From: Kate McMahon [REDACTED] >
Sent: Monday, September 11, 2023 10:25 AM
To: LegislativeServices <LegislativeServices@burnaby.ca>
Subject: Sidewalk expansion/tree canopy concerns

UNION STREET

PUBLIC ENGAGEMENT (2020-14)

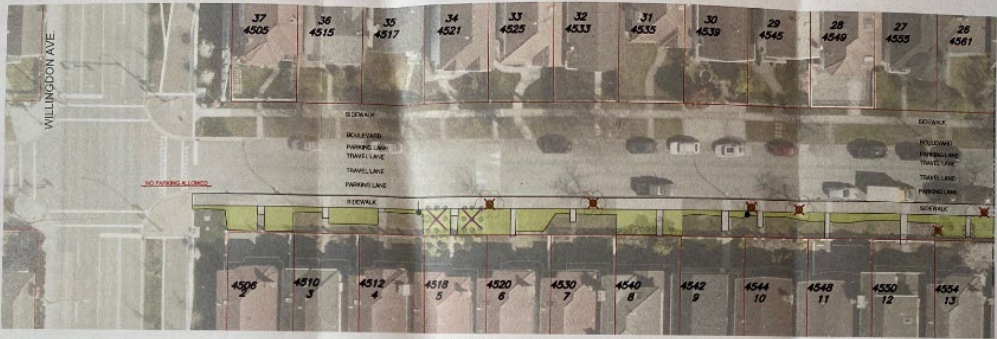
I am highly supportive of the Sidewalk Expansion Program, but have become aware that in the name of active transportation and climate action, a significant number of mature trees are to be felled. I have attached the plan for 2 blocks of Union Street which show that *every single* tree on the south side of the street is to be taken down to accommodate the sidewalk. (Note these trees are **not** to be replaced in this location as there is Telus infrastructure that apparently new trees would interfere with and there are new utility standards that must be adhered to.)

These trees that are to be removed are at least 50 years old. They provide significant shade, cooling the street in the summer. They provide habitat for important wildlife, like pollinators. They capture carbon and improve property value. At a time when we are facing extreme heat, a biodiversity crisis and a climate crisis, replacing trees with concrete seems absurd. The city's tree replacement policy is great, but new trees take many years to contribute to the neighbourhood and environment the way a mature tree does and are difficult to successfully establish in our increasingly hot and dry summers. Every effort should be made to protect mature trees.

A few curves in the plan and/or a more thoughtful approach to planning sidewalks should certainly allow for preserving most of these trees.
